Proposal for a amend the document GRE-82-25 transmitted by GRE-IWG SLR.

The text reproduced below was prepared by expert from Poland. The modifications are marked in **bold** for new and ~~strikethrough~~ for deleted characters.

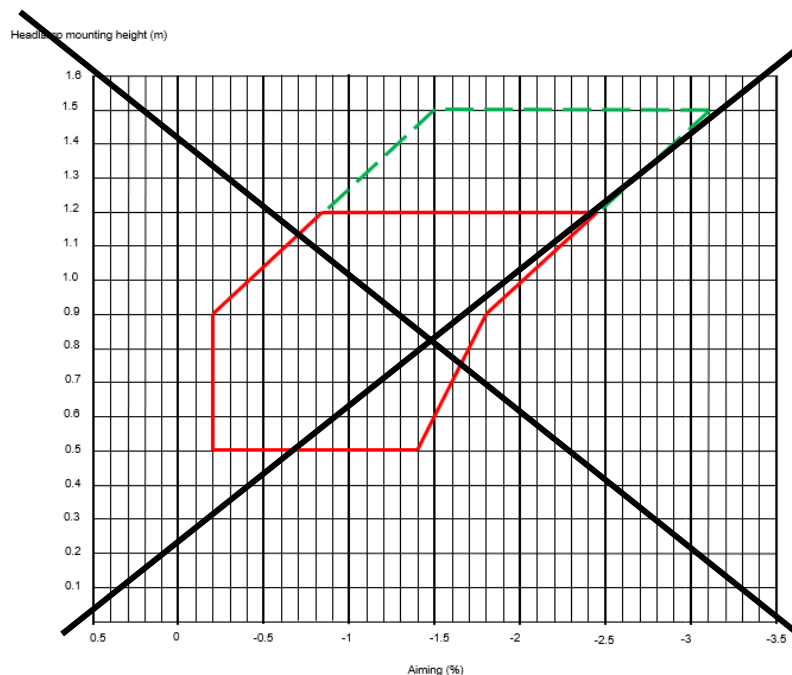
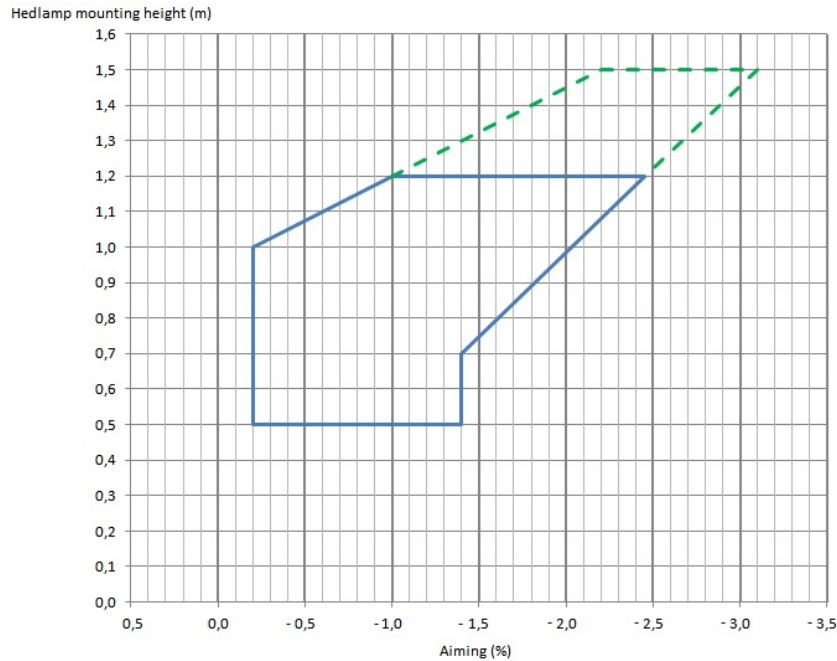
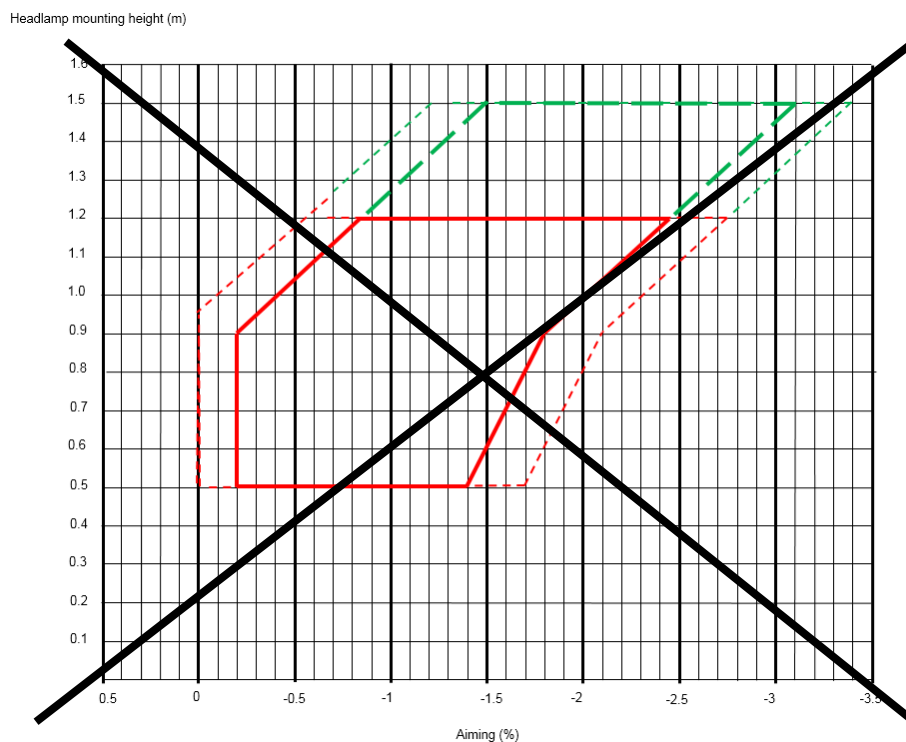
1. Segment A-B. There is no valid technical justification for this proposal. The IWG VGL Group has identified two proposals during its work:
 - Segment A'-C-C' as an expression of the minimum road illumination range of 50 m.
 - Segment A''-B and B-C as an expression of insufficiently substantiated industry demand to maintain a 1.6% inclination for each headlight height above the road surface.

Segment A-B is an artificial creation without technical justification and cannot be accepted.

Poland may agree to a compromise solution (line A-B') as a concession to the industrial lobby to half the value between points A' and A'' as an arbitrary but constant value of 1.4% down. The same value should be maintained until meeting the A'-C-C' line.

2. Segment D-D' is an artificial extension of the segment E-D and it has no correct technical justification. The correct course of this segment is specified in documents GRE-79-23, GRE-79-24 and VGL-10-09 (line 6, segment E'-D''), as the same glare conditions regardless of the reflector mounting height.

- The IWG-VGL group proposed that the CoP requirements would be the same as for the type-approval. Therefore, Poland will not support the proposal to extend them by another 0.4%. (p. 1.3.2 Annex 9 in the GRE-82-25), because adding the uncertainty of inclination measurement in real conditions and taking into account the unevenness of the diagnostic floor, there is a real danger that the cut-line will be above the horizon and the range of road illumination will be shortened below the acceptable distances.
